247 (GLA/GLB) - Rearview Camera Noise Optimization

Topic number	LI54.71-P-080349
Version	6
Function group	54.71 - Camera and radar-assisted assistance systems
Date	8/25/26
Validity	247 (GLA & GLB) with all of the following: - Model Year 2024 and later (Option code 804, 805, 806, etc...) - Option code 459 or 485 (Steel spring variants)
Reason for change	XSS case handling

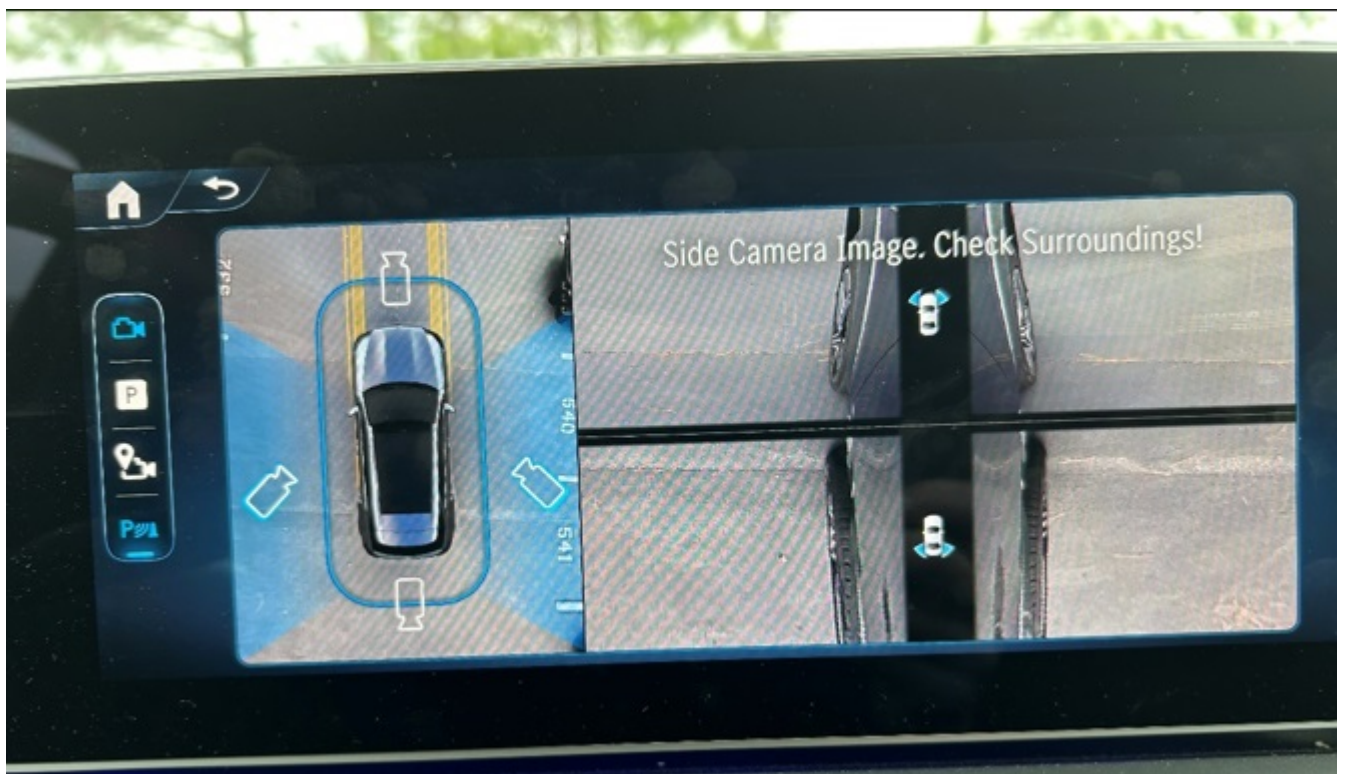
After both control units have been SCN coded, the "Movable 3D View" feature in the head unit will no longer be available. With this change there will be two distinct differences:

- 1) The "3D" icon when in the top down vehicle view, will no longer be present on the head unit.
- 2) The digital rendering of the vehicle with the ability to spatially move around the vehicle is no longer possible. This view is replaced with 2D static images of the left and right sides.

- Rear camera flap when calibrating after a key cycle bus sleep will stay open to 29 MPH and then close. Will re-open, when calibrating, at 9 MPH.
- The head unit screens mentioned above appear the same as "View AFTER SCN Coding" as shown in the attachment.
